SUBJECT: SAFETY EVALUATION OF GE TOPICAL REPORT, NEDC-31858P, REVISION
2; "BWROG REPORT FOR INCREASING MSIV LEAKAGE LIMITS AND
ELIMINATION OF LEAKAGE CONTROL SYSTEMS," SEPTEMBER 1993

SAFETY EVALUATION BY THE OFFICE OF NUCLEAR REACTOR REGULATION
BWROG GENERIC RESOLUTION
FOR THE BWR MAIN STEAM ISOLATION VALVE LEAKAGE

FIG. 1

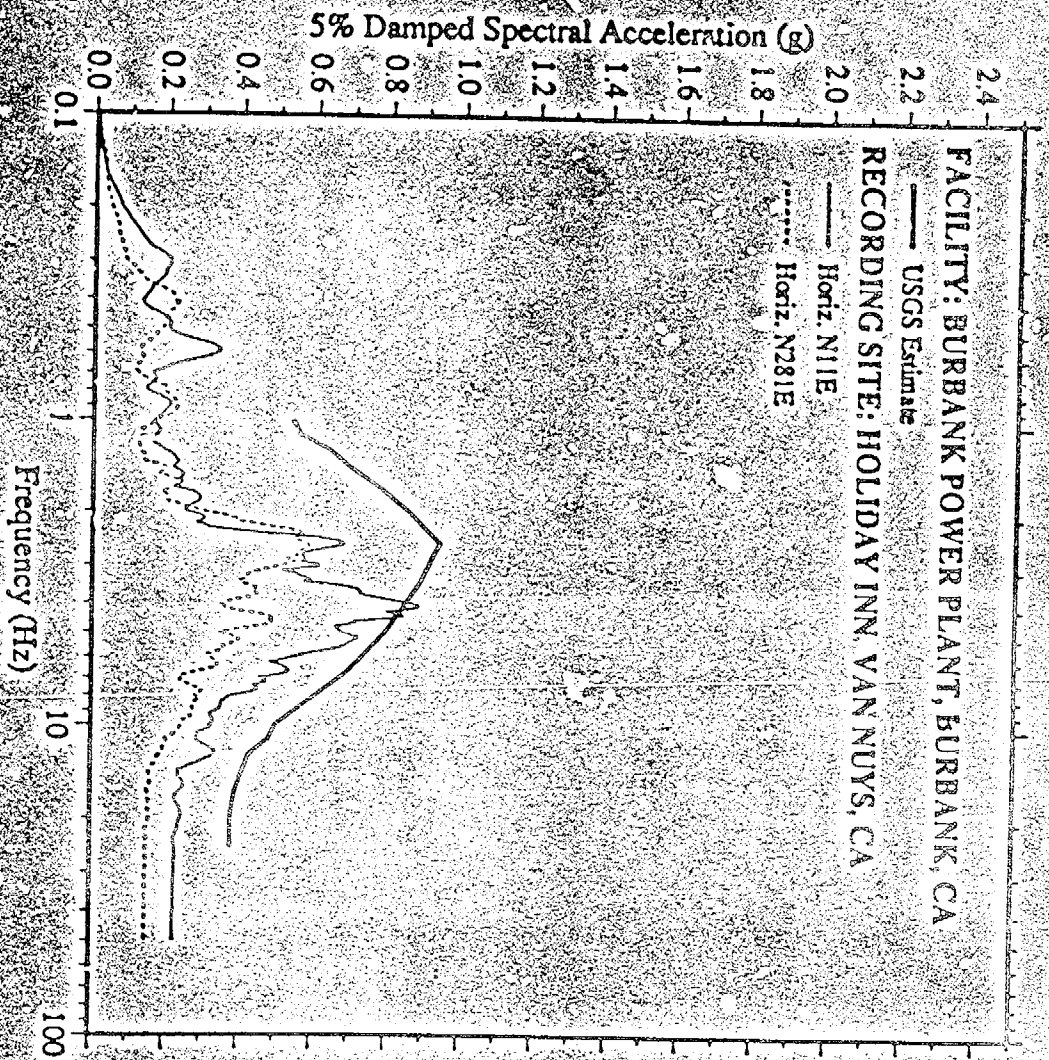
1971 San Fernando earthquake made at the Holiday Inn in Van Nuys, CA. The main adjustment made to the Holiday Inn record was to account for differences in ground motion attenuation between the recording site and the Valley Steam and Burbank facilities. USGS estimates for the Valley Steam and Burbank facilities as well as the Holiday Inn response spectrum and ground motion are shown in Figures 1 and 2, respectively.

The facility ground motion estimates shown in Figures 1 through 13 of this attachment have been reviewed and accepted by the staff for inclusion in BWROG's earthquake experience database. These 13 facility ground motion estimates may be used to verify the seismic adequacy of equipment in the alternative MSIV leakage pathway for plants referencing BWROG's Topical Report, NEDC-31858P, Revision 2. With the exception of the facility estimates for the Valley Steam Plant, the Burbank Power Plant, and the Moss Landing Power Plant, the nearby recording site or on-site response spectra, shown in the attached figures, should be used to estimate the facility ground motion. USGS estimated response spectra should be used for the Valley Steam Plant and the Burbank Power Plant and the PG&E estimated response spectrum should be used for the Moss Landing Power Plant.

FIG. 3

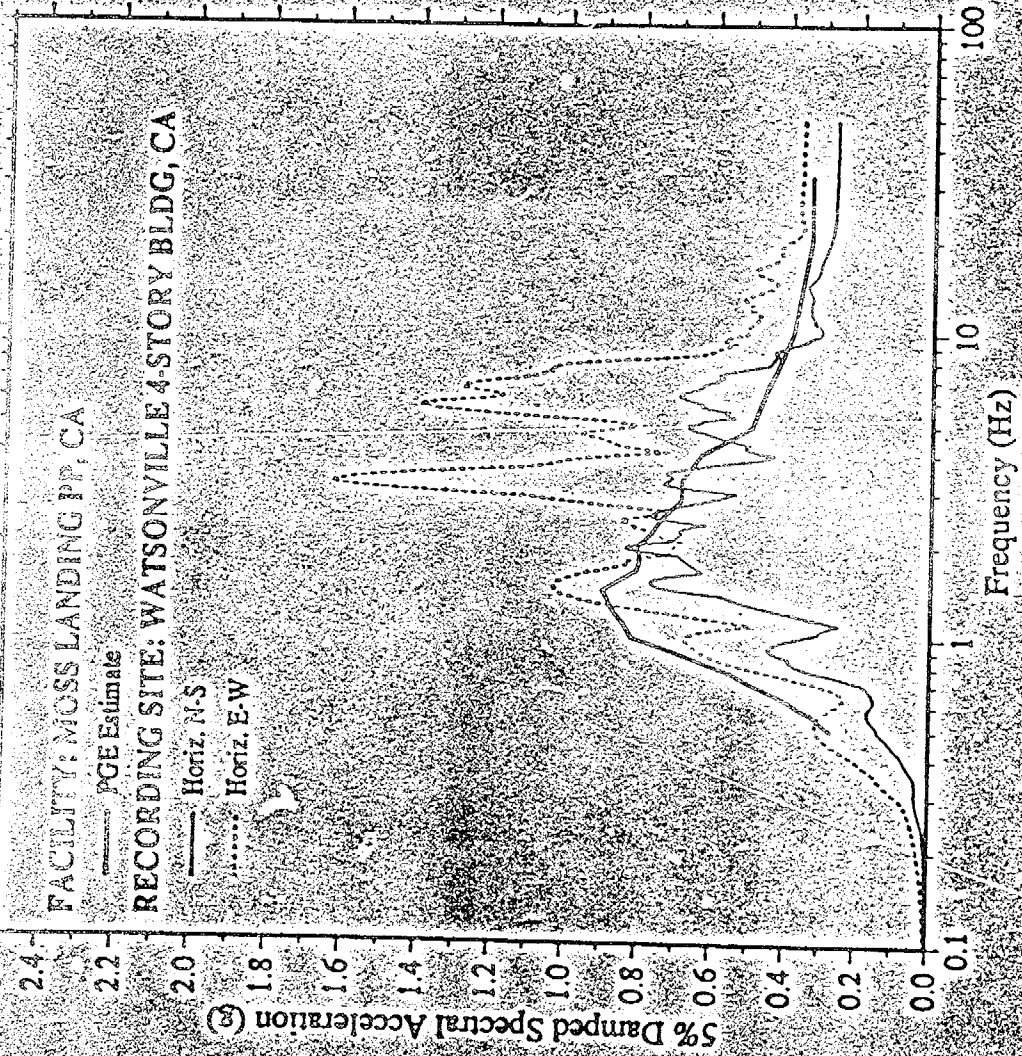
For the El Centro Steam Plant in El Centro, CA, the closest recording site is less than 2 km from the plant and is underlain by similar soils. In addition, there were several other seismic instruments in the area that also recorded the 1979 M6.6 Imperial Valley earthquake. Variations in the ground motion from this earthquake were extensively studied and reported in the literature. Therefore, the staff was able to conclude that the seismic recording site and the El Centro Steam Plant experienced similar levels of ground motion. The recording site ground motion and response spectra are shown in Figure 3.

FIG. 4

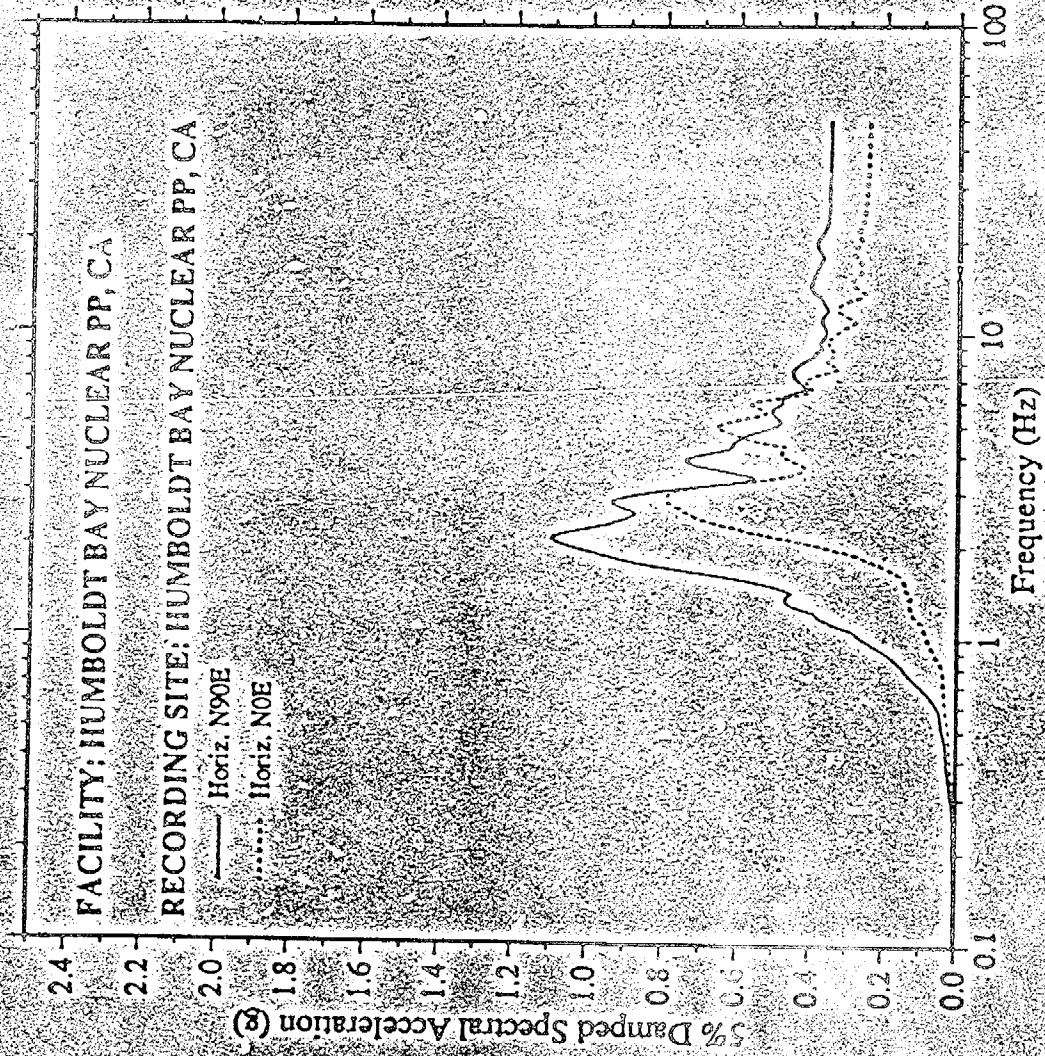
The EQE estimate of ground motion at the Moss Landing Power Plant is based on a study performed by Pacific Gas and Electric (PG&E), the owner of the Moss Landing Power Plant. The staff concluded that this estimate of ground motion at the Moss Landing facility from the 1989 M7.1 Loma Prieta earthquake is technically sound and comprehensive. The PG&E estimate, as well as the ground motion and response spectra from the nearest recording site in Watsonville, CA, are shown in Figure 4.

FIG. 5

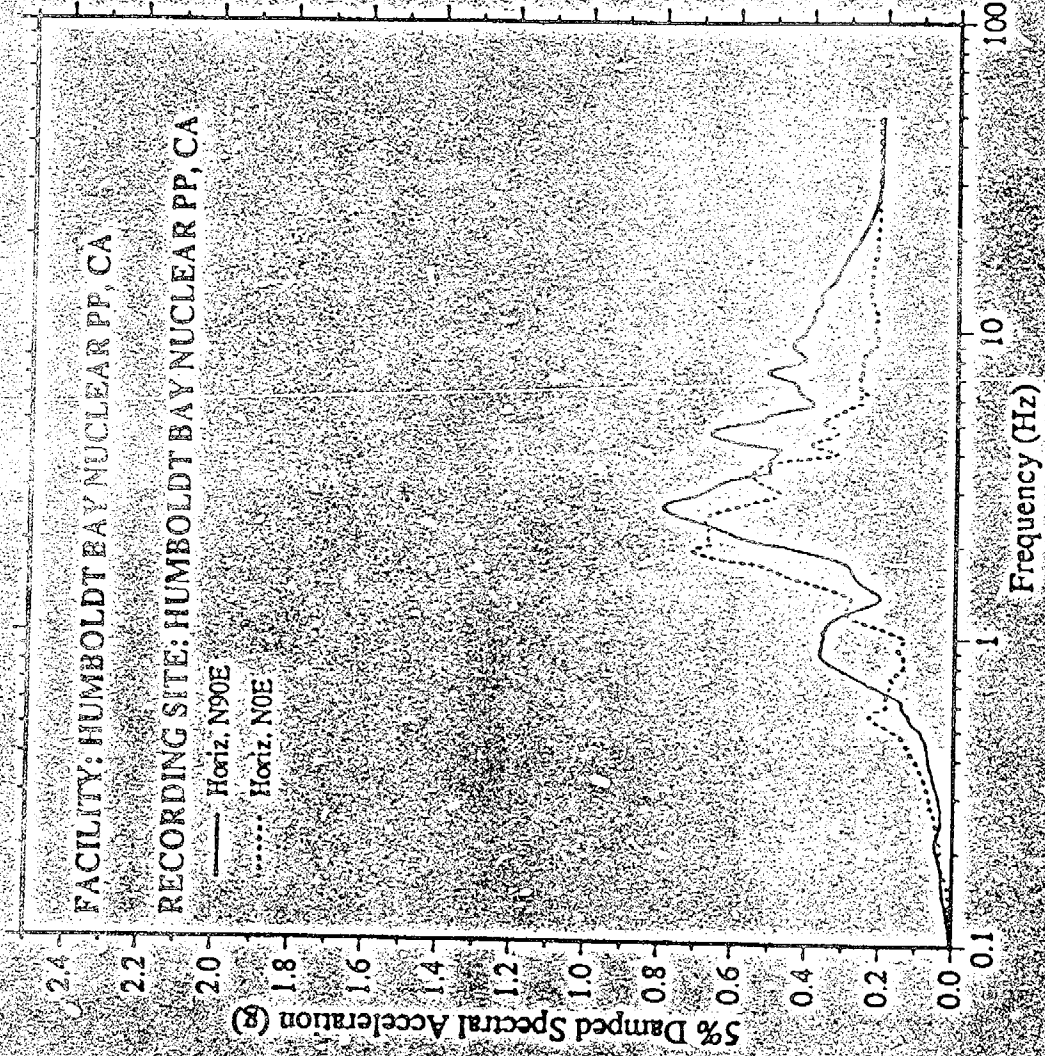
On-site recordings of ground motion made at Humboldt Bay Power Plant (HBPP) from the 1975 M5.5 Ferndale earthquake and the 1992 M6.9 Petrolia mainshock and M6.2 aftershock are shown in Figures 5, 6, and 7, respectively. EQE also listed an additional 1992 Petrolia aftershock in the earthquake experience database. However, the response spectrum at HBPP from this aftershock is enveloped by the three other HBPP response spectra. For the 1980 M7.2 Eureka earthquake, listed in the database, only a scratch plate record of the response spectrum at 2% of critical damping was made at HBPP. Since the accuracy of this record is questionable, the staff does not accept this facility-event pair for inclusion in the database.

FIG. 8

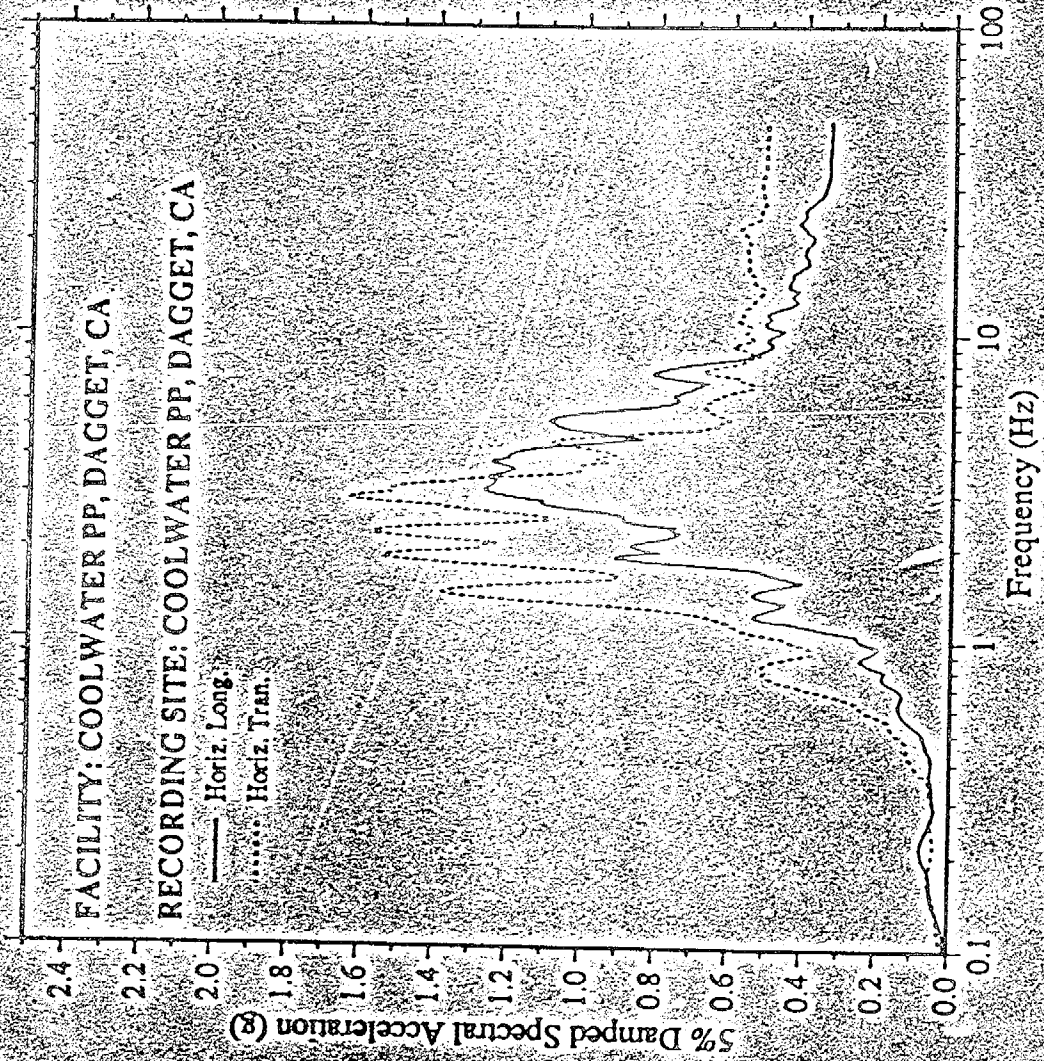
On-site recordings made at Las Ventanas Units 1 & 2 in Quintero Bay, Chile, from the 1985 M7.8 Valparaiso earthquake, shown in Figure 8, have been reviewed and accepted by the staff. Also, the staff has reviewed and accepted the on-site recording made at Coolwater Power Plant in Daguerre, CA, of the 1992 M7.3 Landers earthquake, shown in Figure 9. The staff has not reviewed the Coolwater recording of the 1992 M6.5 Big Bear earthquake. However, the ground motion response spectrum from this event is most likely enveloped by the Coolwater spectrum of the Landers earthquake.

FIG. 11

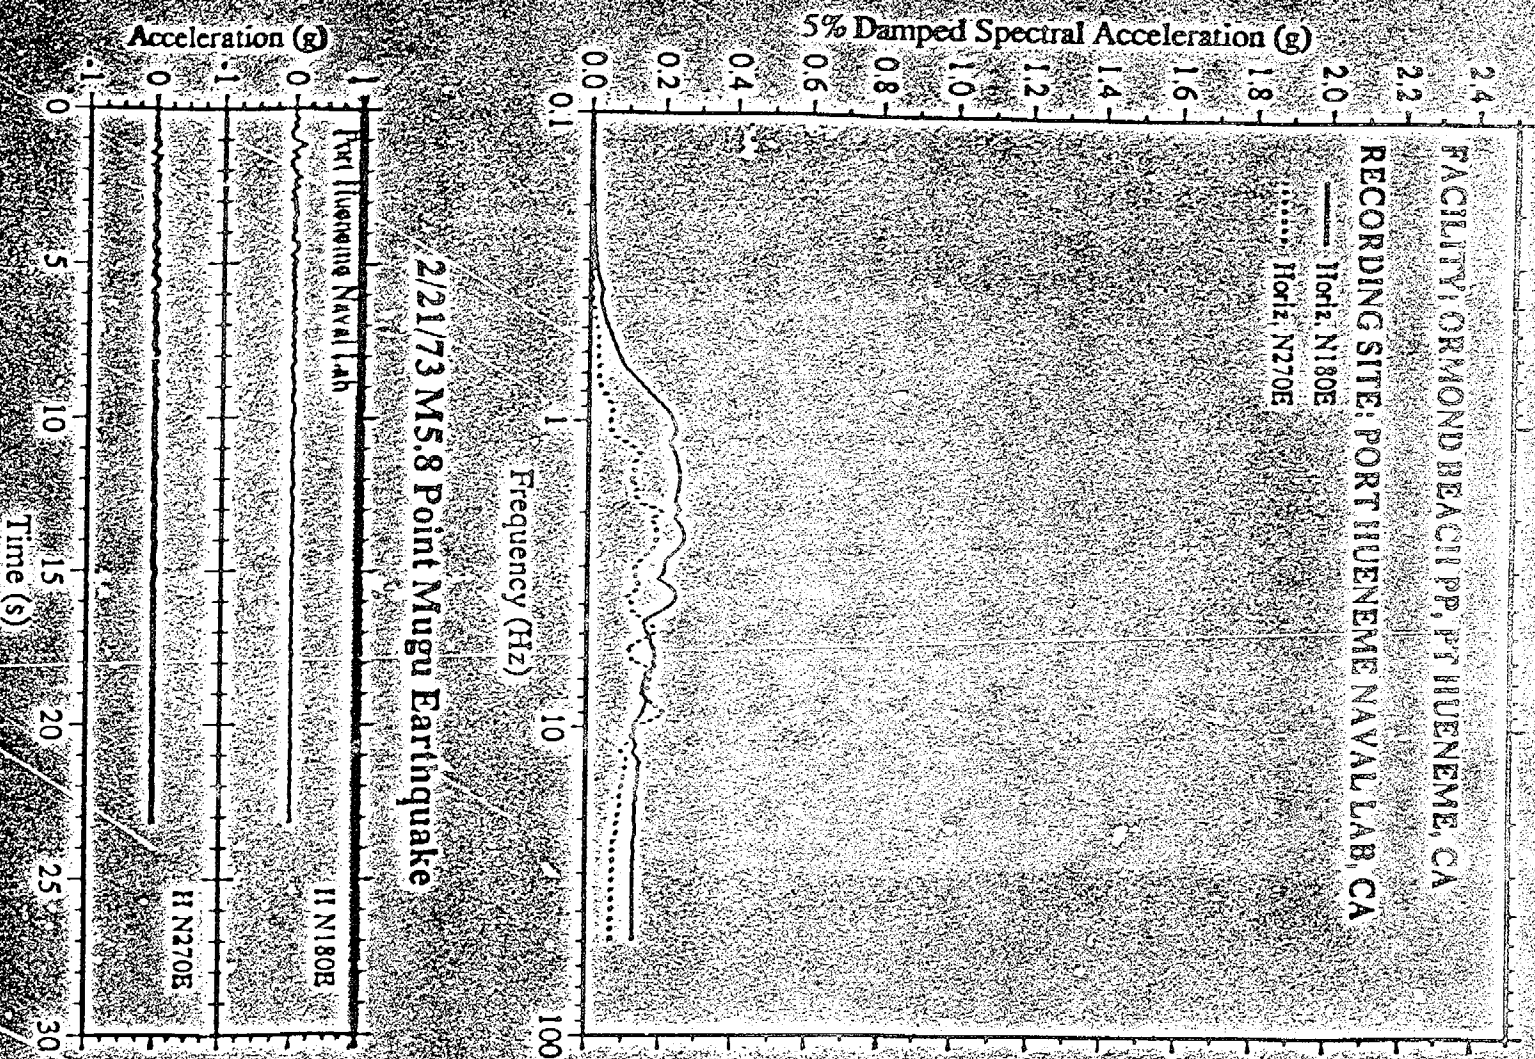
The Grayson Power Plant in Glendale, CA, is located about 2 km from the Glendale City Hall. The latest EQE earthquake experience database (Reference 6) incorrectly gives a facility-to-recording site distance of 16 km. Both the facility and recording site are located on similar thicknesses of alluvium and therefore, the recording of the 1971 M6.6 San Fernando earthquake made at Glendale City Hall is an acceptable estimate of the ground motion at the Grayson Power Plant (Figure 11). Similarly, the Port Hueneme Naval Laboratory recording of the 1973 M5.6 Point Mugu earthquake, shown in Figure 12, is an acceptable estimate of the ground motion at the Ormond Beach Power Plant in Port Hueneme, CA.
